# CDP-292/392

## SERVICE MANUAL

Since models CDP-292 / 392 are almost the same as CDP-291 / 391, please use the service manual for CDP-291 / 391.

This describes only the parts that differ from those of CDP-291 / 391.

PRINTED WIRING BOARD

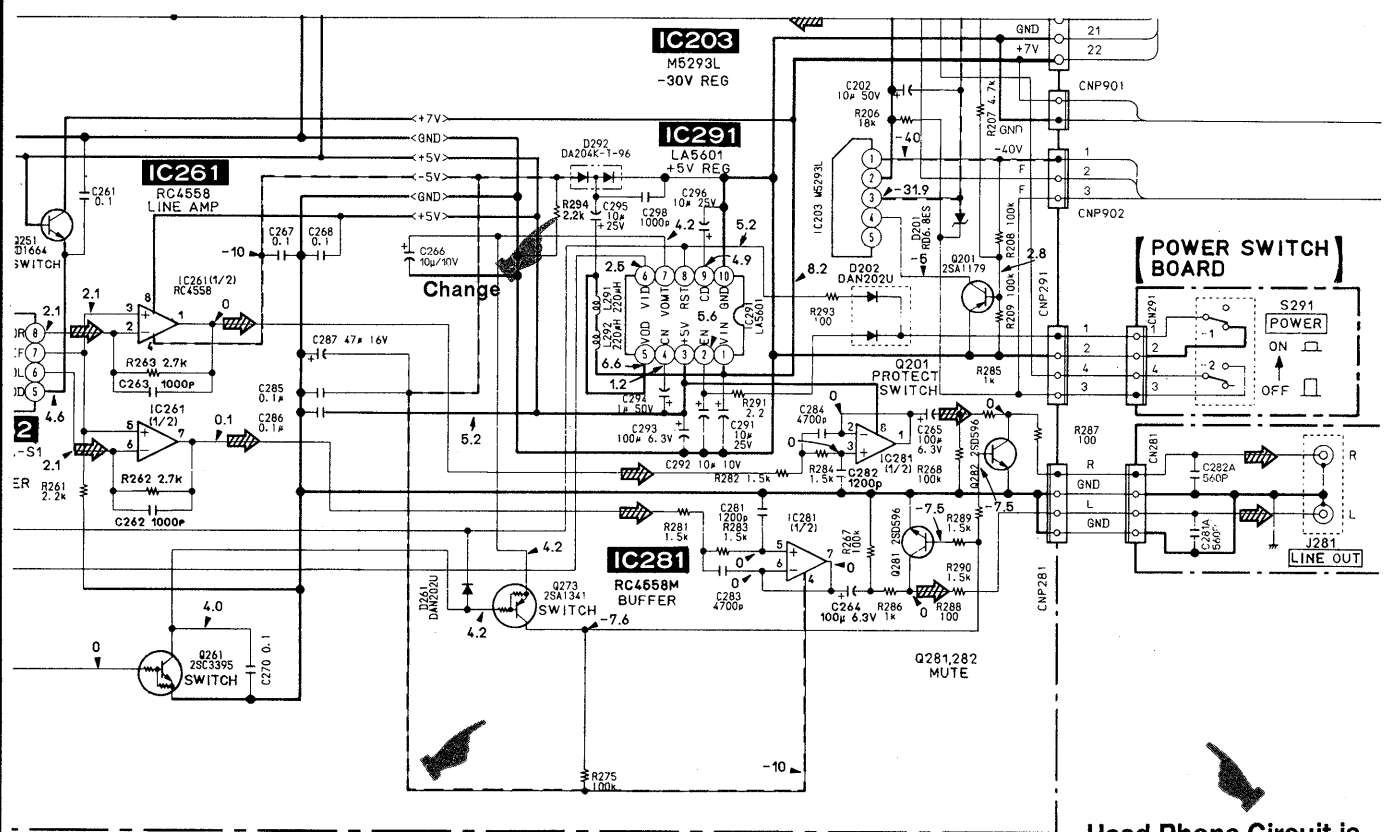
Change

Head Phone Circuit is not used
